**Re: Initial Submission Review: Parklands Coal Creek Infrastructure Site Plan (ISP)**  
**Application Number: DA-2289-05**  
**Case Number: 2024-6023-00**

## *Initial Submission Review*

# PARKLANDS COAL CREEK STRUCTURE SITE PLAN

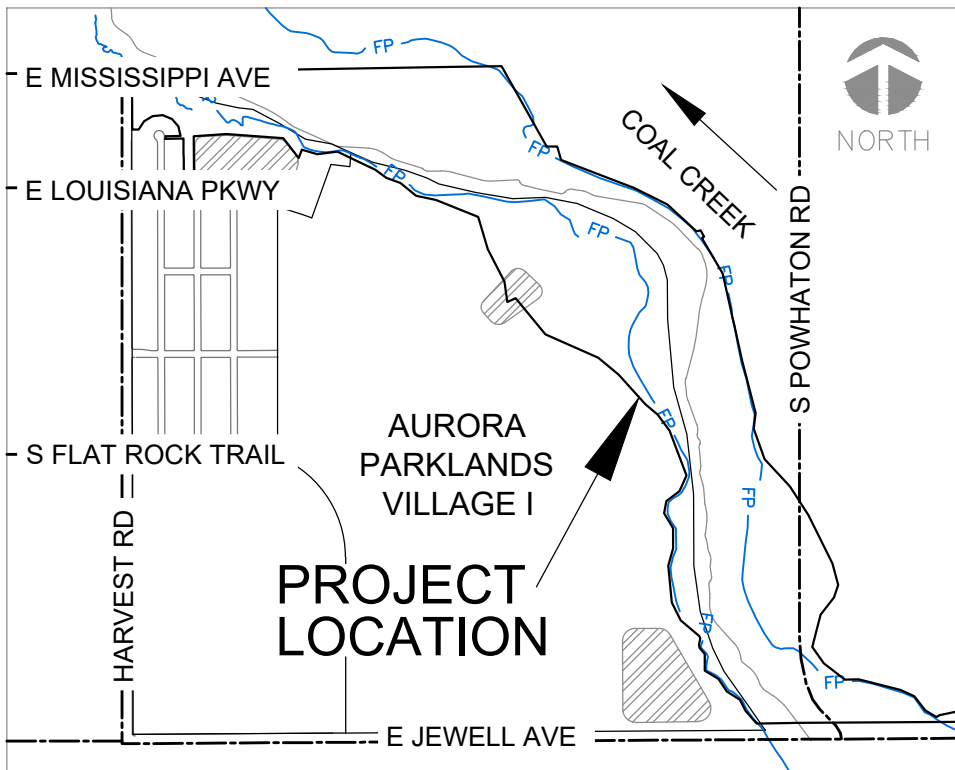
The site plan will not be approved by Aurora Water until the preliminary drainage letter/report is approved.

Revise this site plan as applicable per comments on the Preliminary Drainage Report

RESPONSE: NOTED

**PLAN & PROFILE STA. 10+00 - 24+00**

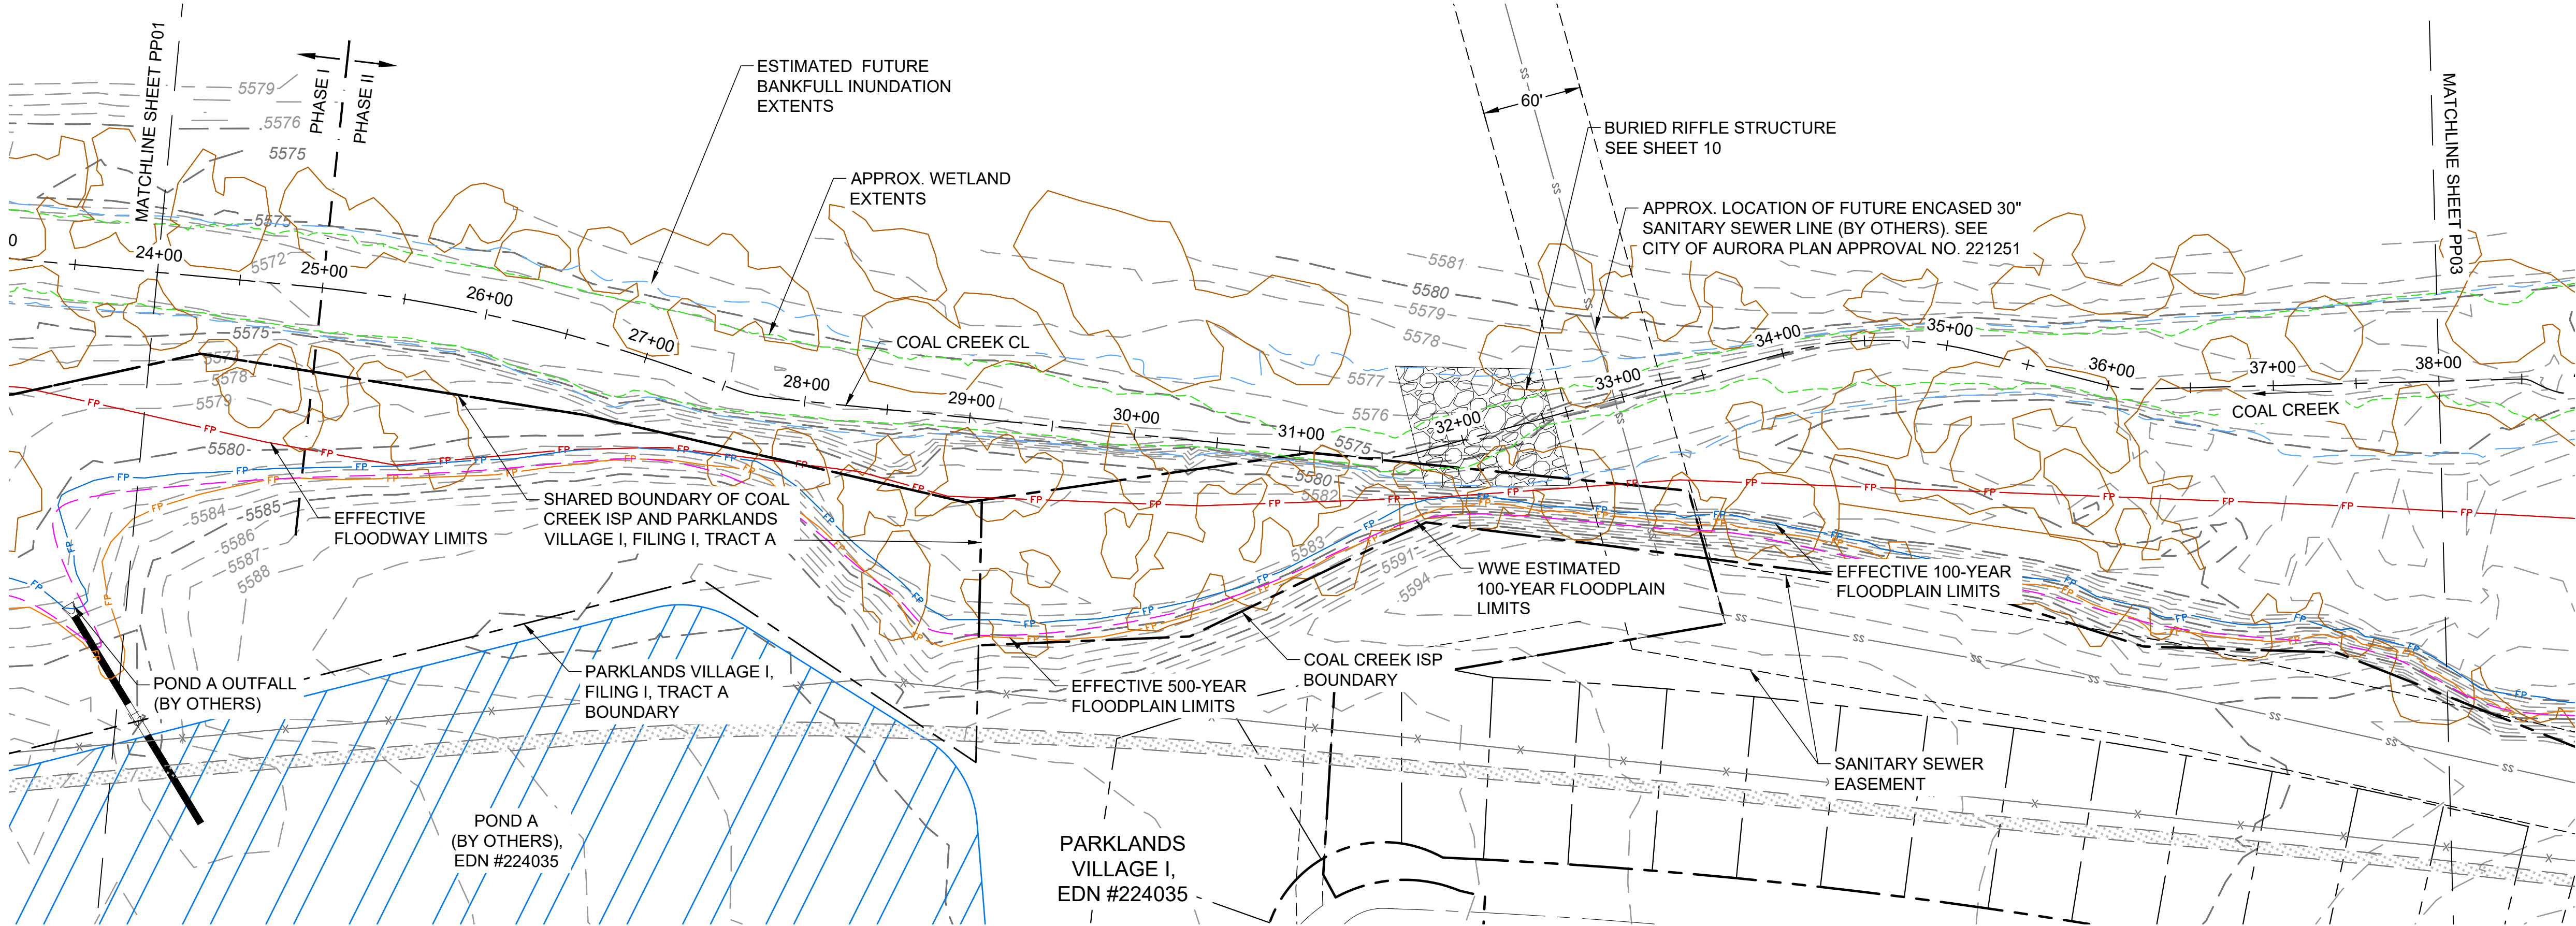
11B. Sheet 3 - In support of the comment provided on the cover sheet, it would be useful to see the route of the maintenance path/regional trail as it approaches Mississippi Avenue and Harvest Road.

**RESPONSE: AN OVERALL SITE PLAN HAS BEEN ADDED TO THE ISP AND SHOWS THE REGIONAL TRAIL AS IT APPROACHES BOTH ROADS**

PLAN & PROFILE STA. 66+00 - 80+00

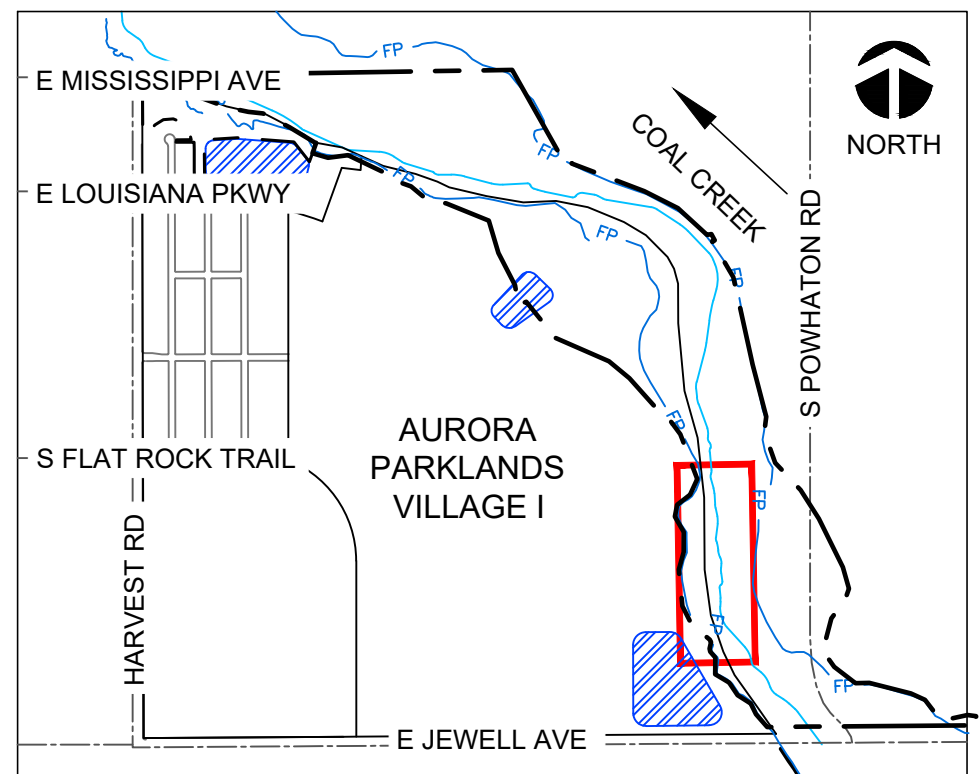
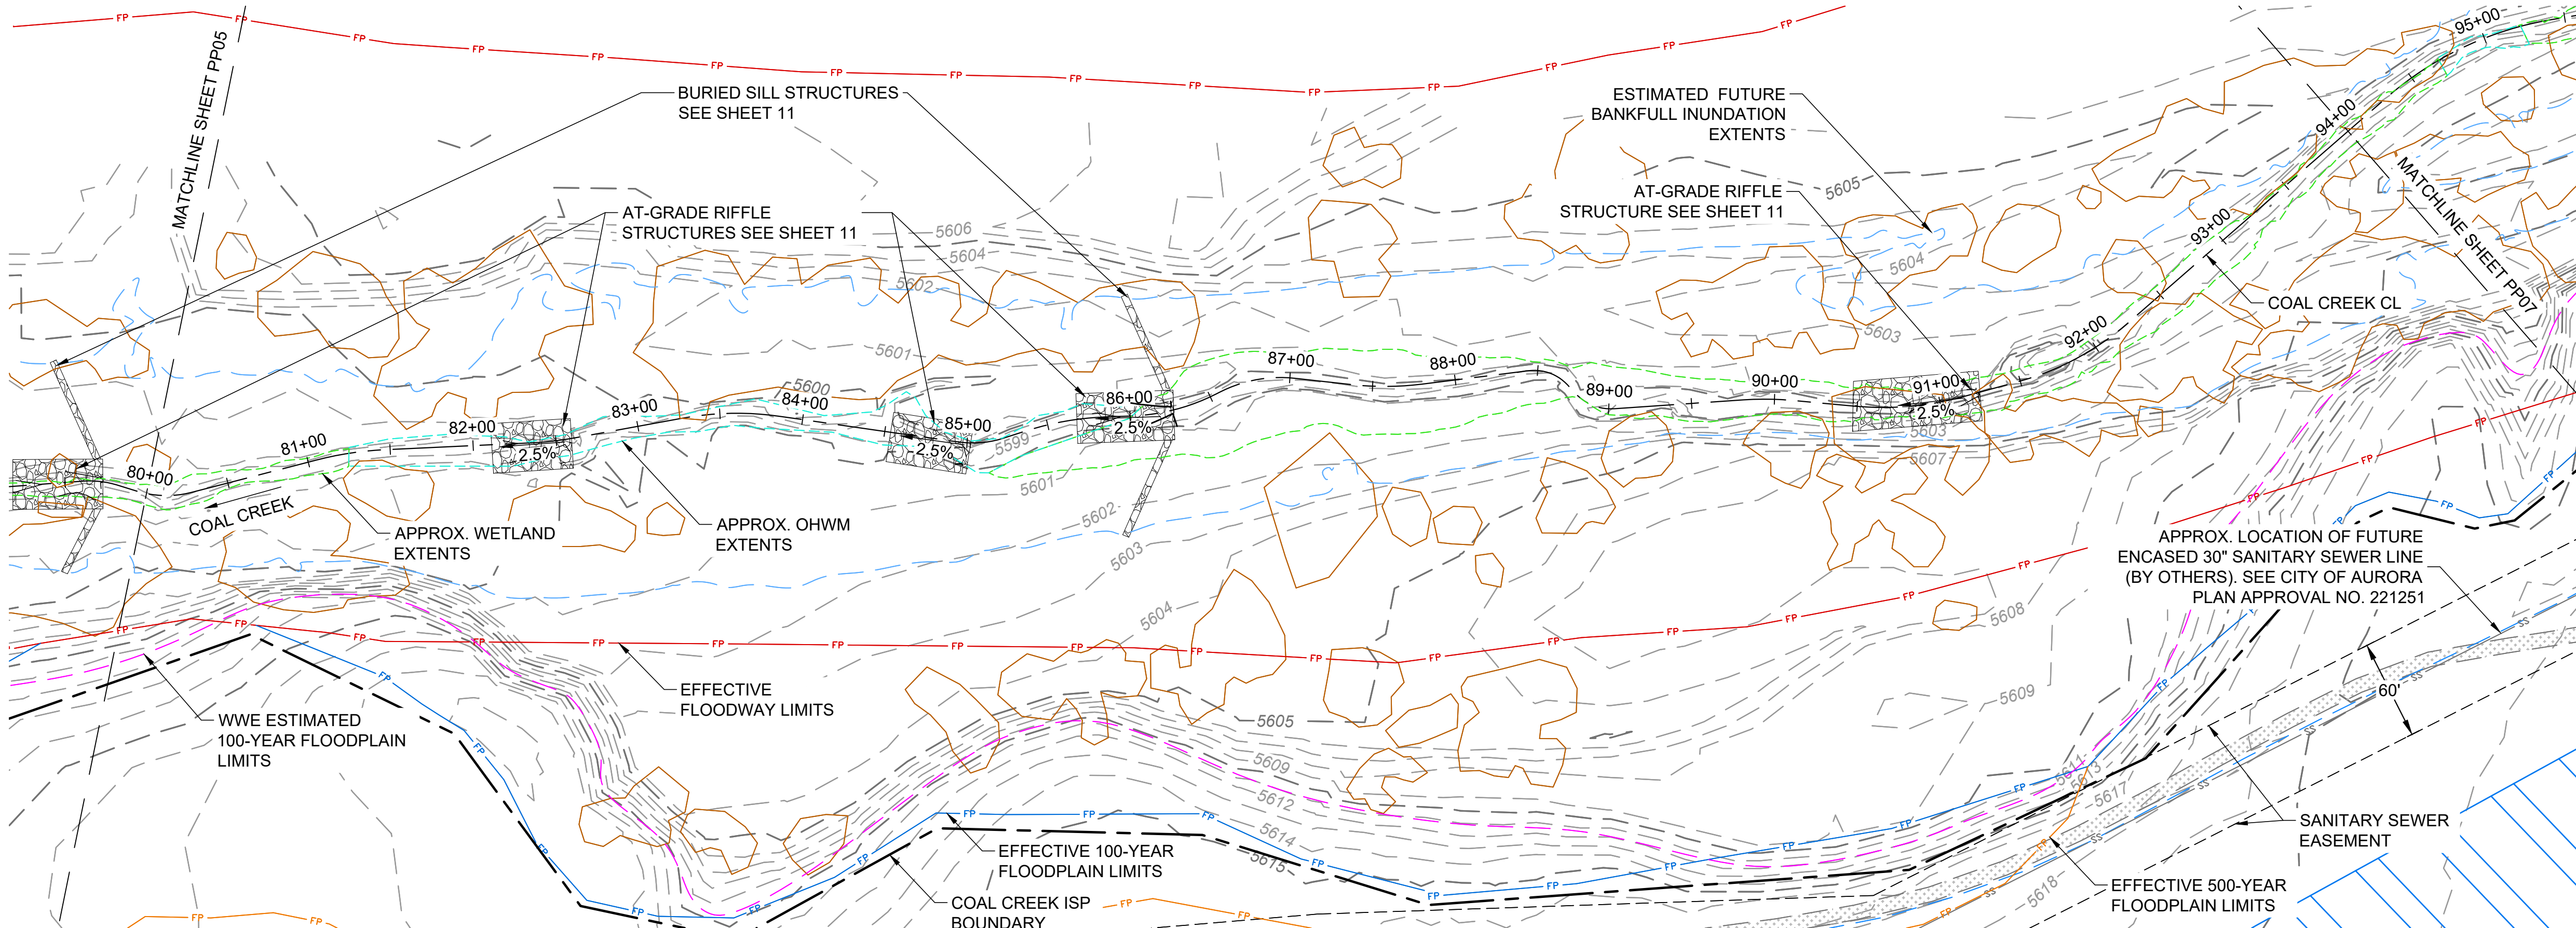
11C. Sheet 7 - Please identify boundaries that indicate where the future PROS properties will be located about the residential lots and other future developed uses.

PSCo also has existing overhead electric distribution facilities crossing the project as shown on Sheet PP05 between Stations 66+00-80+00. Bear in mind that per the National Electric Safety Code, a minimum 10-foot radial clearance must be maintained at all times from all overhead electric facilities including, but not limited to, *construction* activities and permanent structures.

**RESPONSE: AN OVERALL SITE PLAN HAS BEEN ADDED TO THE ISP AND SHOWS THE TRACT BOUNDARIES AND RESIDENTIAL LOTS**

**RESPONSE: Clearance will be maintained.**

PLAN & PROFILE STA. 80+00 - 94+00

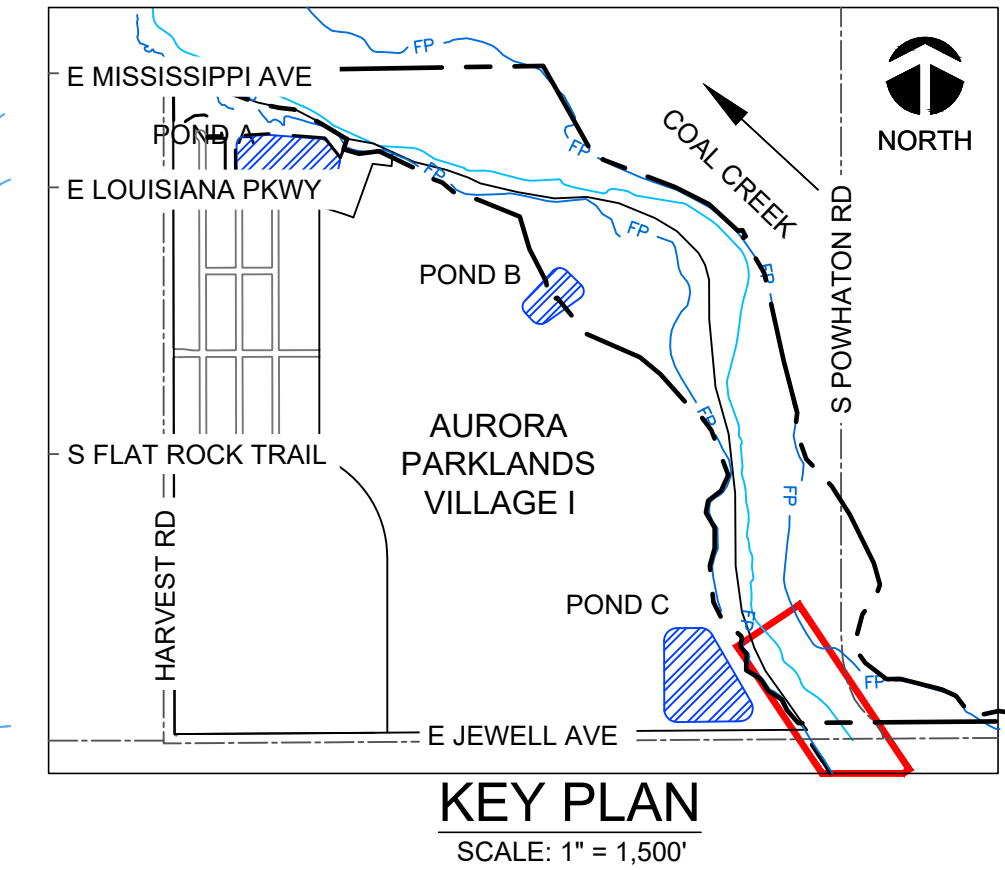
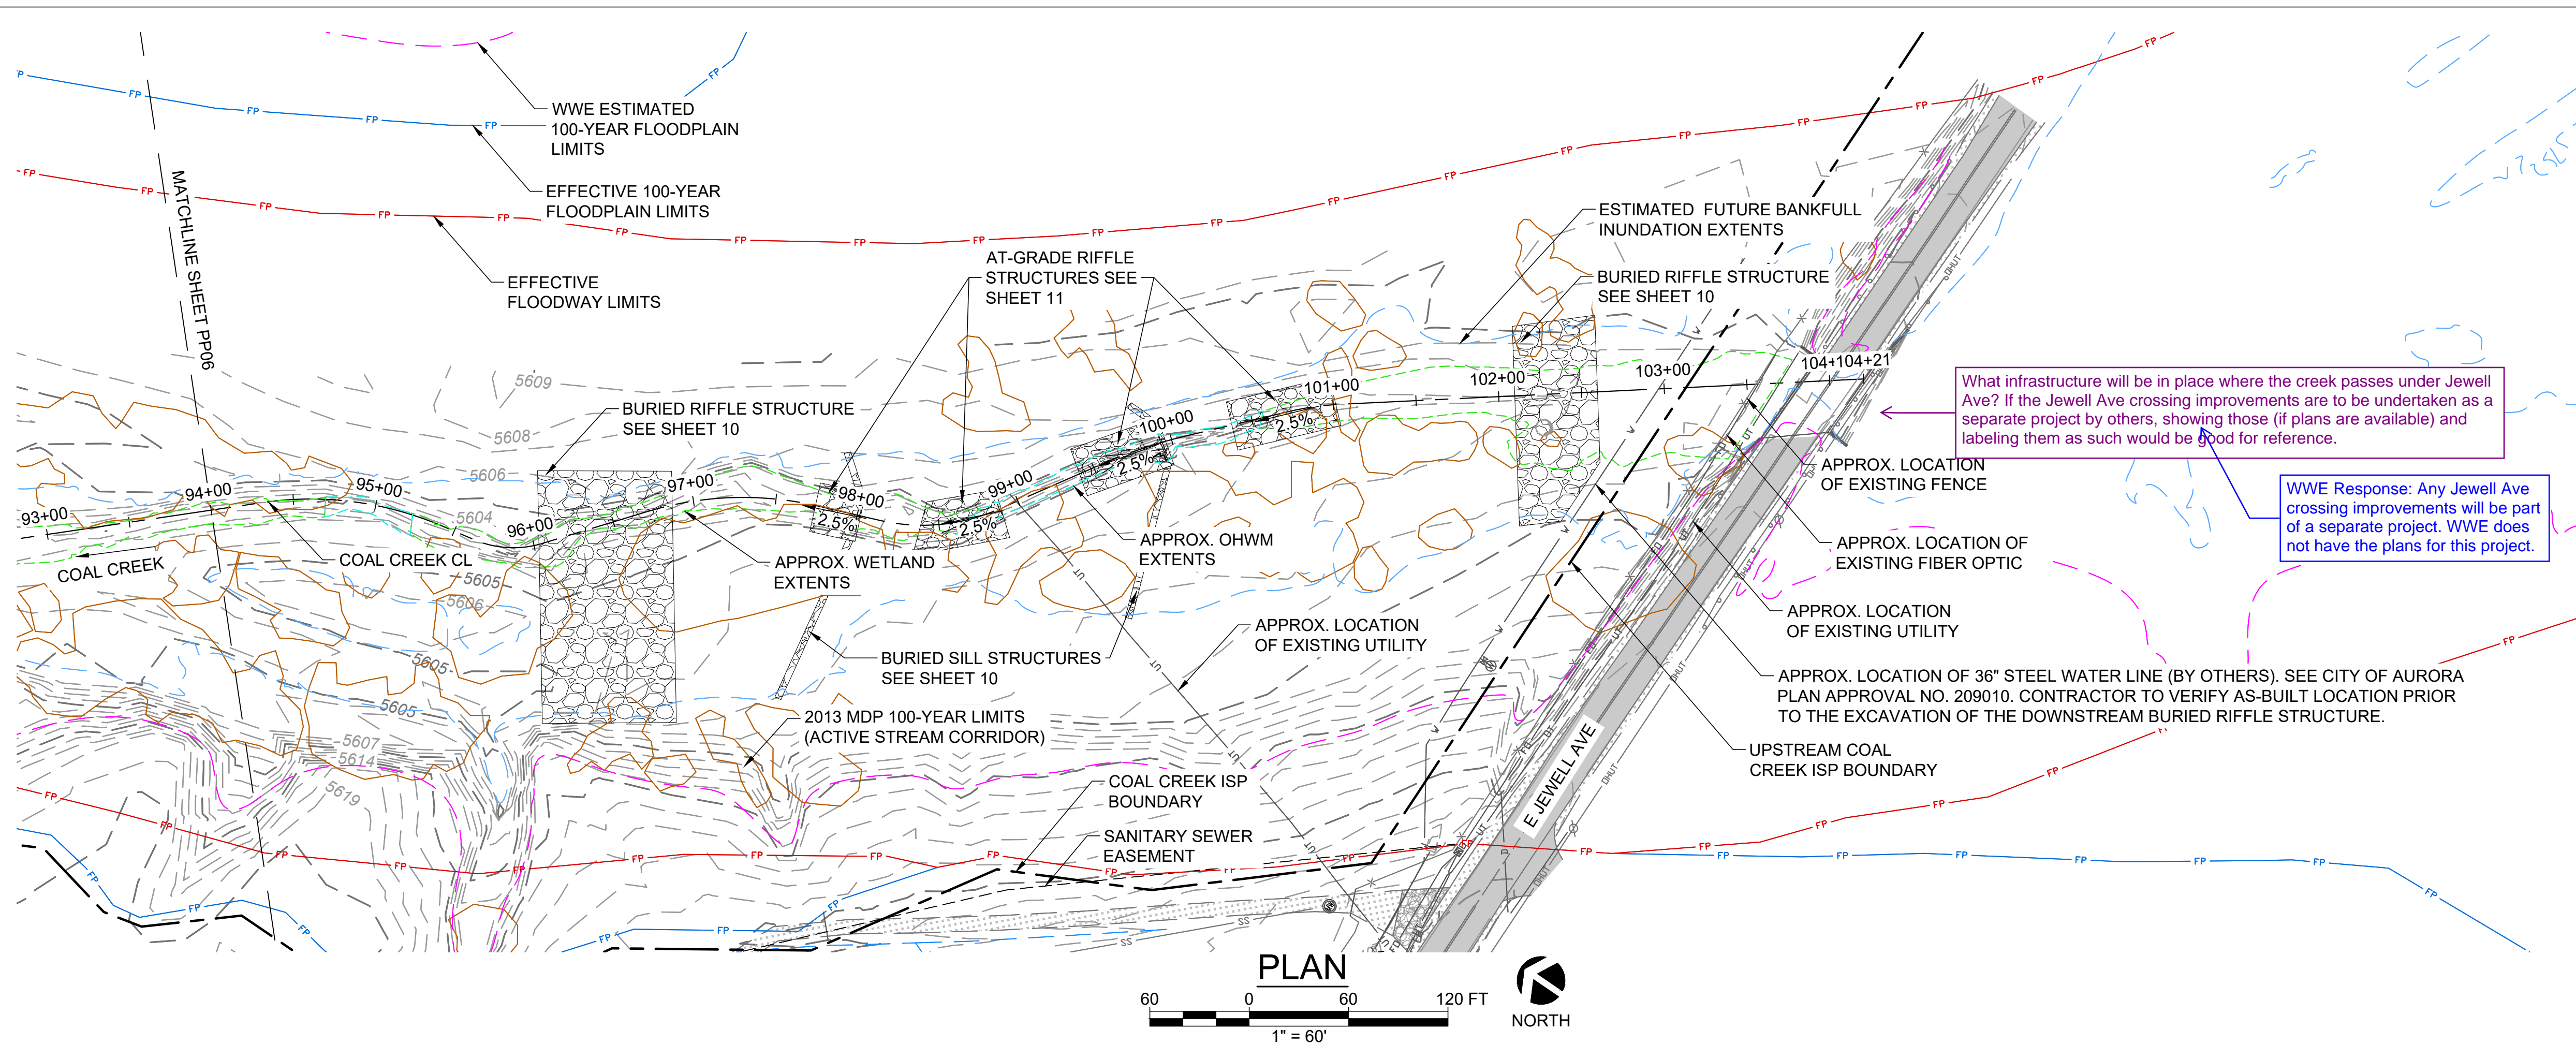
11D. Sheet 9 - What infrastructure will be in place where the creek passes under Jewell Ave? If the Jewell Ave crossing improvements are to be undertaken as a separate project by others, showing those (if plans are available) and labeling them as such would be good for reference.

**RESPONSE: THIS WILL BE ADDRESSED IN THE JEWELL AVE ISP WHICH HAS NOT BEEN COMPLETED YET.**
